June 19, 2012

**Re: Amendment #10 to the November 18, 2011 Application and Soil Management Plan
Additional Soil Sampling Plan for the Southwestern Golf Course, June 2012
Birch Hills Golf Course
2250 East Birch Street, Brea, California**

SITE PLAN
AND SOIL SAMPLING LOCATIONS

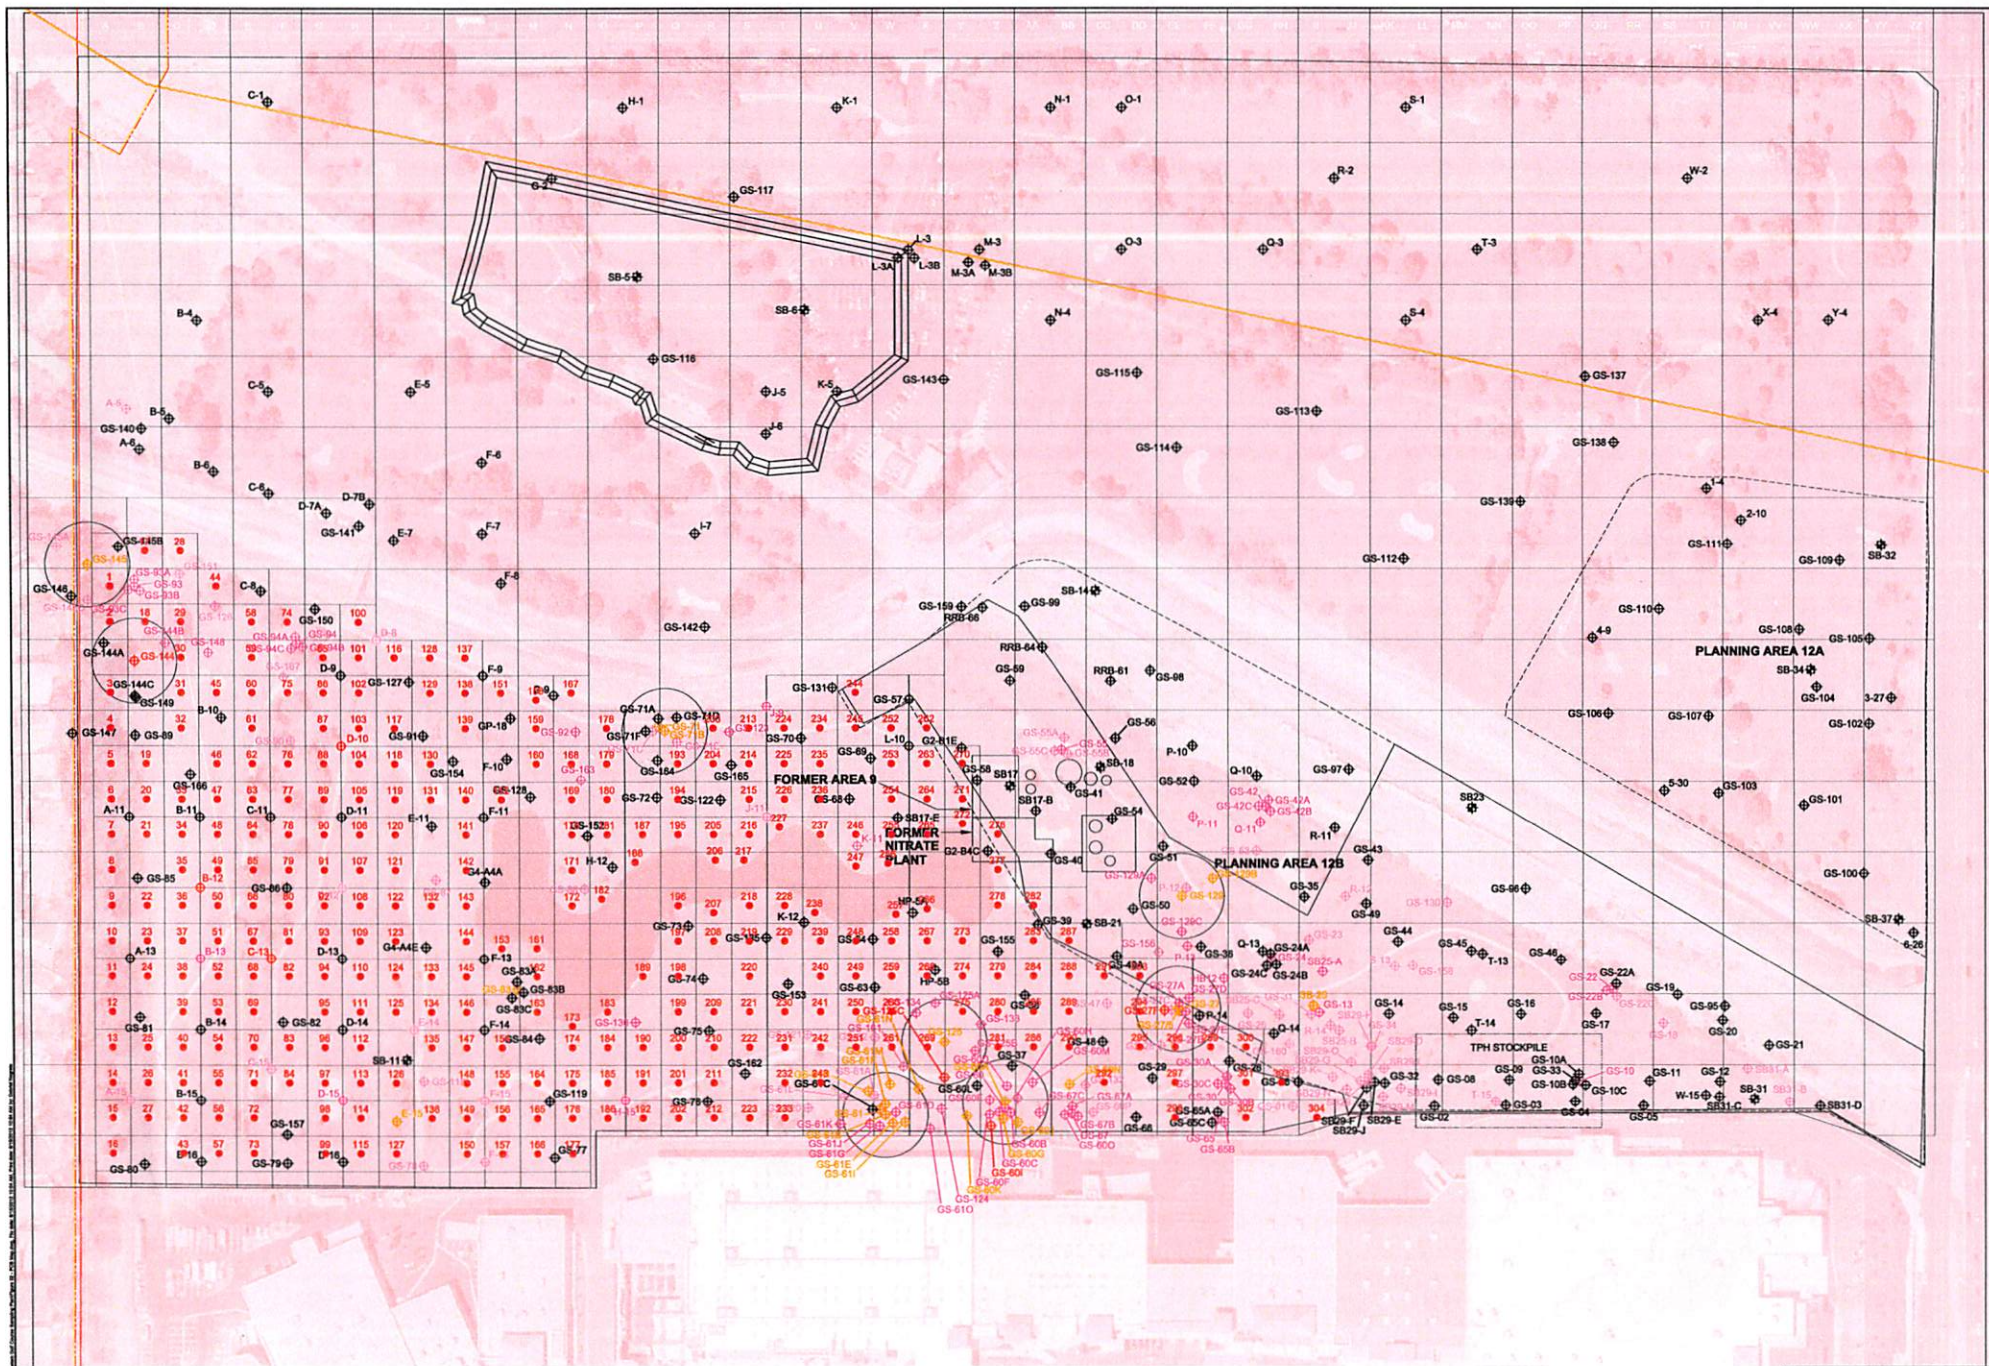
The sampling program will include placing 304 proposed borings in the center of the 50-foot by 50-foot grids shown on the southwestern portion of the golf course, if an existing boring is not already within that grid (Figure 2). Each boring will be advanced to 2 feet below ground surface (ft bgs) using a roto-hammer, hand auger or direct-push drilling rig to drive a sampling device containing a 2-foot long acetate sleeve to collect a continuous soil sample for laboratory analysis. After reaching the desired depth, the sampling device will be retrieved and the acetate sleeve will be split in half providing samples from 0 to 1 foot bgs and from 1 to 2-feet bgs. The sample sleeve ends will be covered with Teflon tape and a plastic end cap; labeled with the sample date, location and depth; and placed in a container for shipment to an off-site laboratory. The borehole will then be backfilled with bentonite chips hydrated in lifts in place, and then covered by the grass plug removed at the start of the process. The entire soil core will be used by the laboratory, so boring logs will not be prepared for these borings. Otherwise, soil collection and soil handling procedures will be consistent with Section 3.5 of the November 18, 2011 Soil Management Plan.
